ADDENDUM NO. CC-2

NORTHEAST COMMUNITY COLLEGE WELLER BUILDING BASEMENT REMODEL
801 East Benjamin Avenue
Norfolk, NE 68702-0469
BCDM Project No. 3507-01

addendum

project name: Northeast CC – Weller Building Basement Remodel

PROPOSED SITE PLAN
SCALE: 1" = 10'

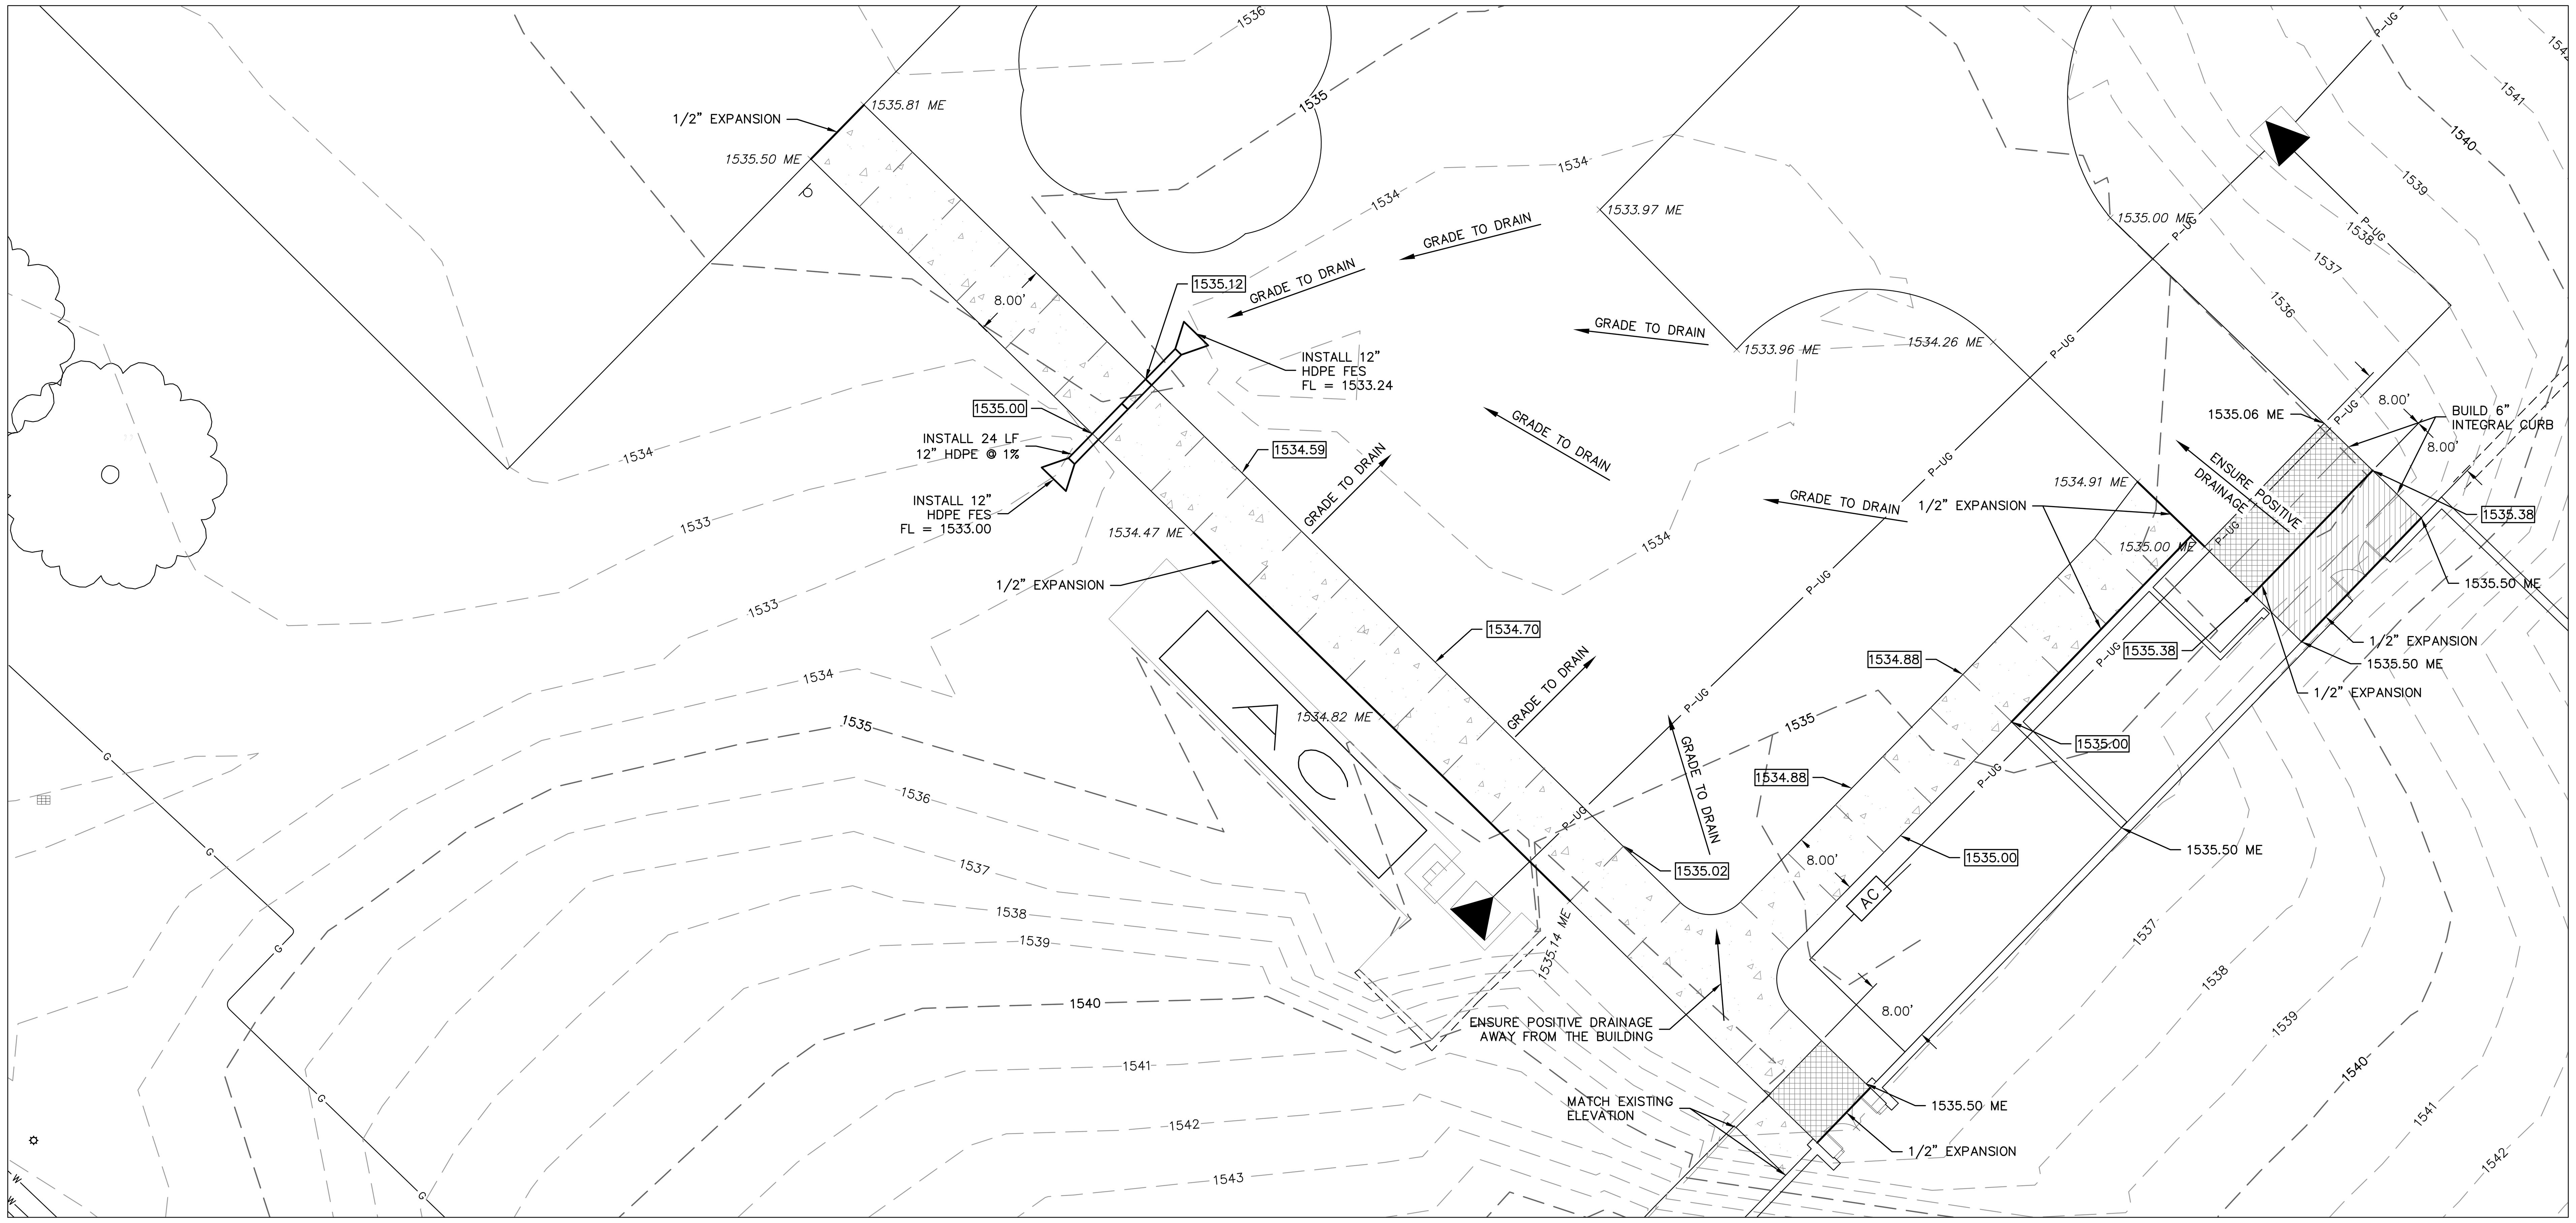
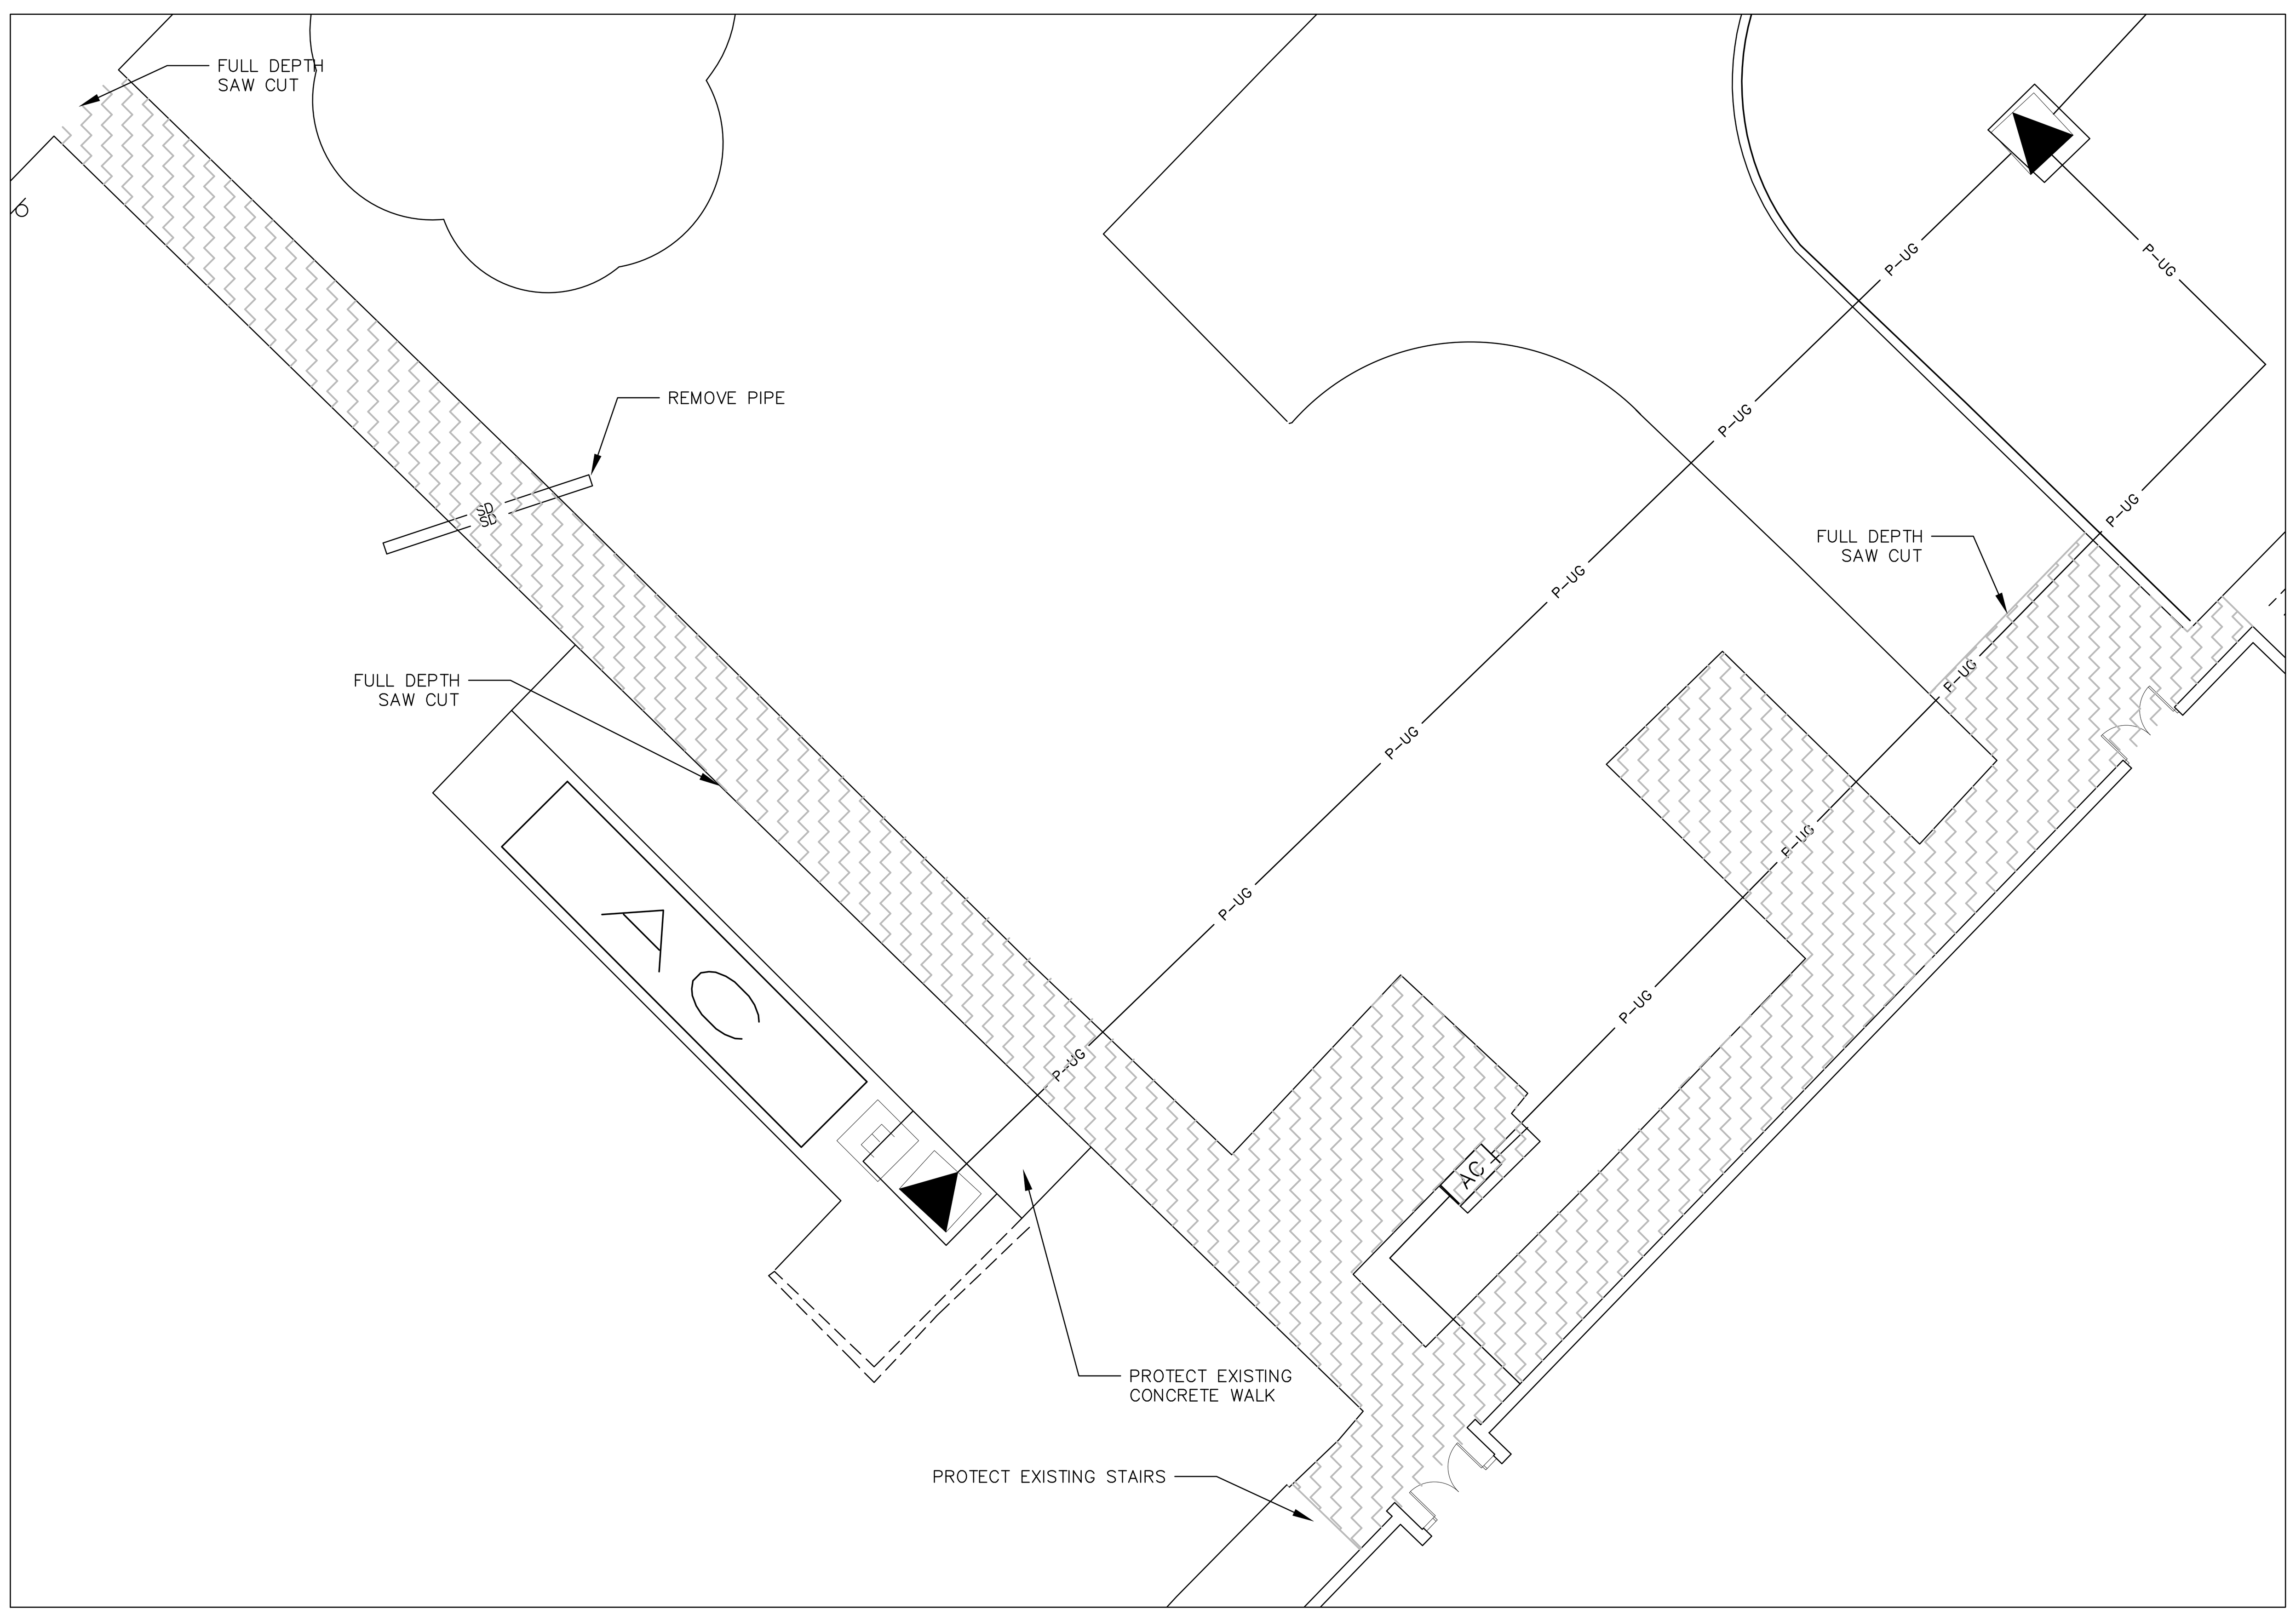
SHEETS C1-1 Added to define revised sitework

1 LOWER LEVEL - HVAC
1/8" = 1'-0"

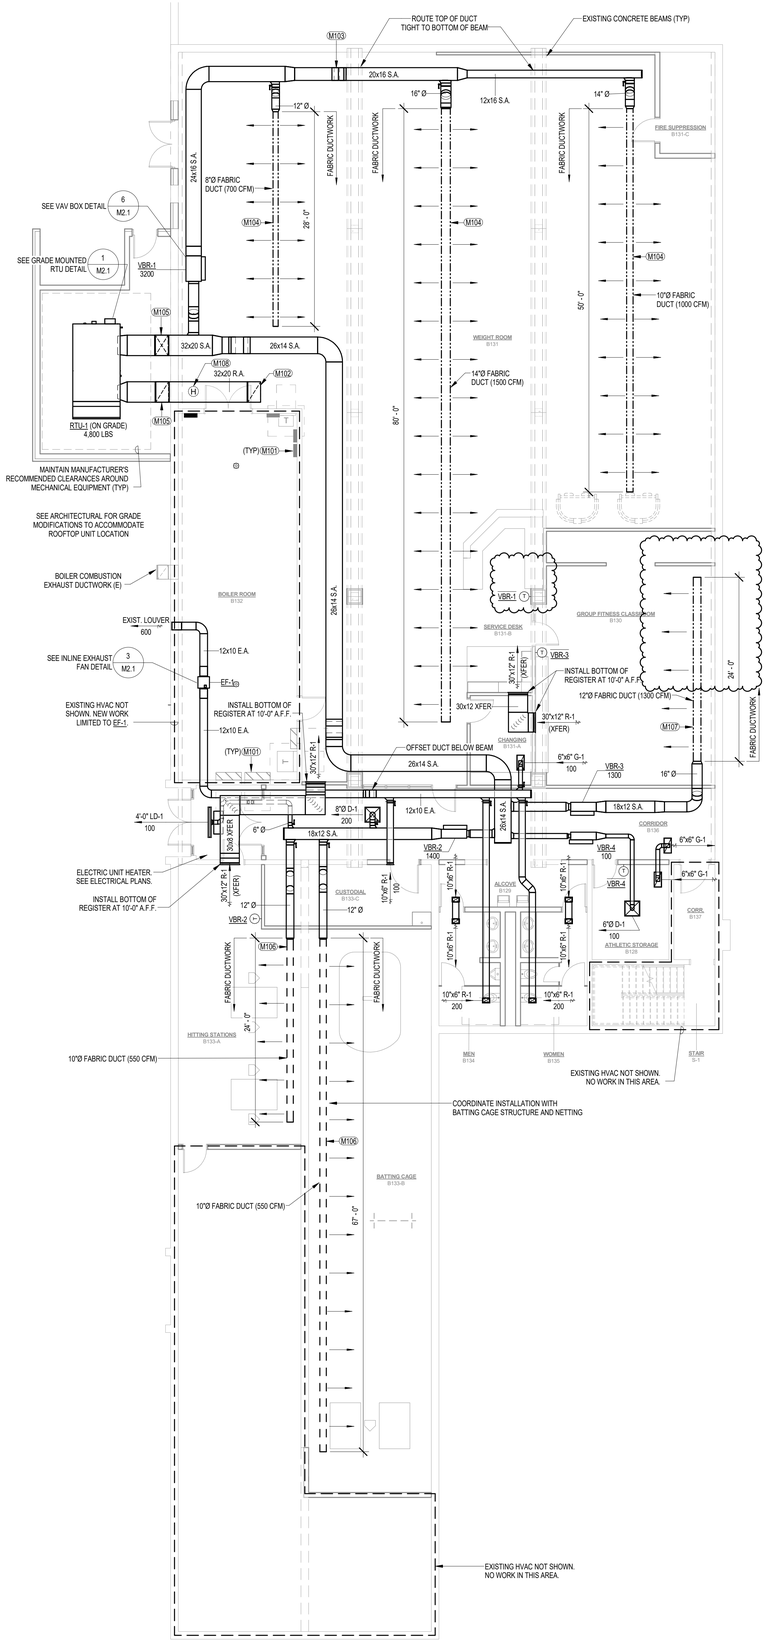
1. Sheet M1.1 – Plan 1
    a. Service Desk B131-B: Revise location of VBR-1 thermostat.
    b. Group Fitness Classroom B130: Revise length of fabric ductwork to accommodate storage room.

2 LOWER LEVEL - PLUMBING & MECHANICAL PIPING DEMOLITION
1/8" = 1'-0"

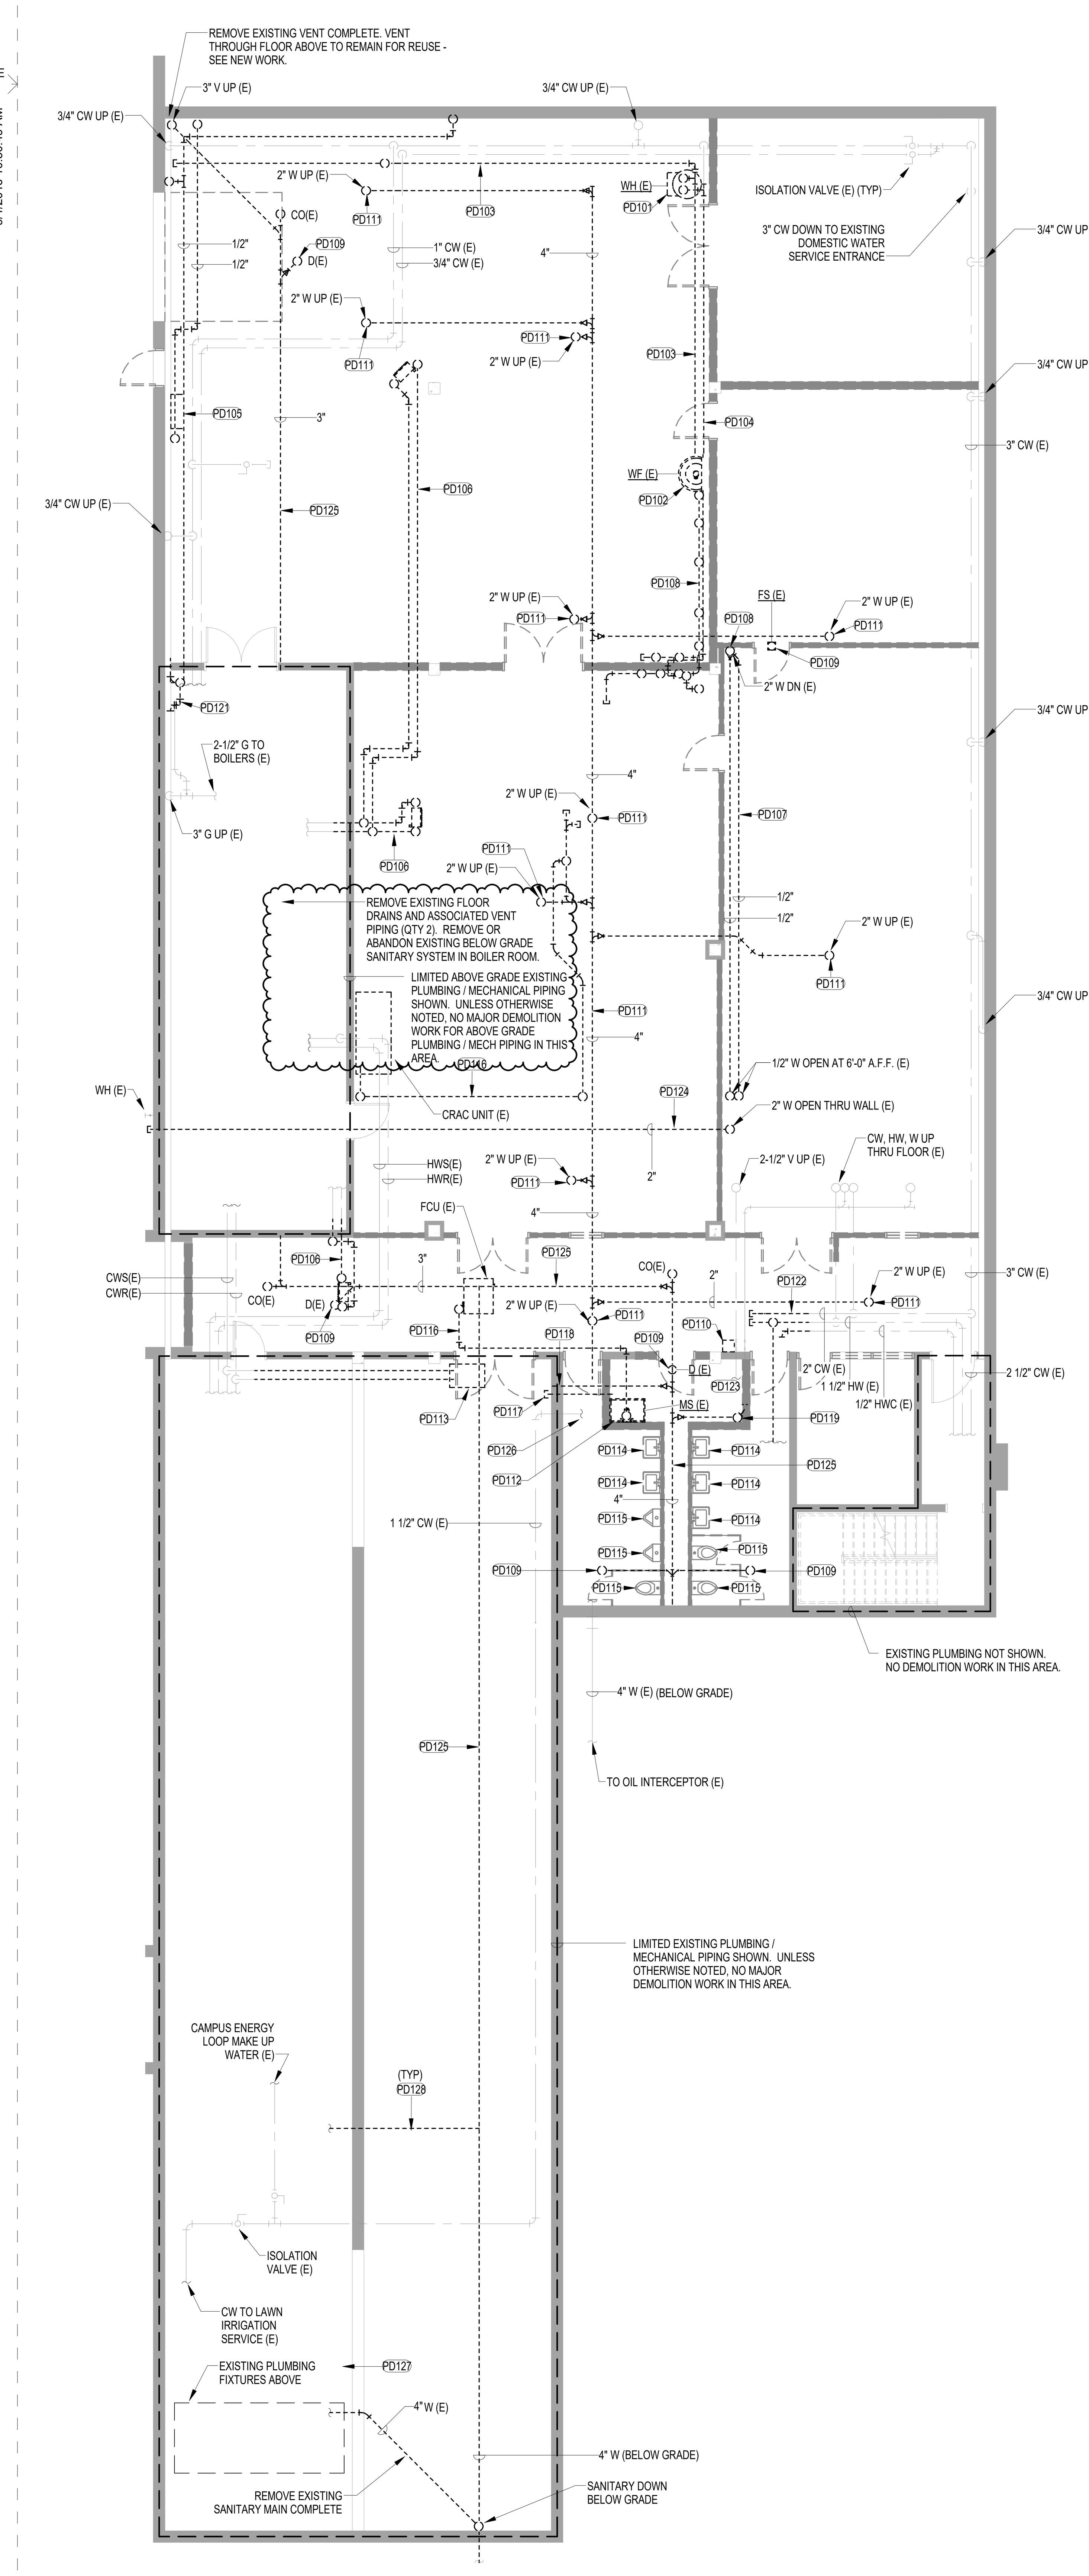
5. Sheet P1.1 – Plan 2
    a. Boiler Room B132: Revise notes regarding plumbing scope of work.
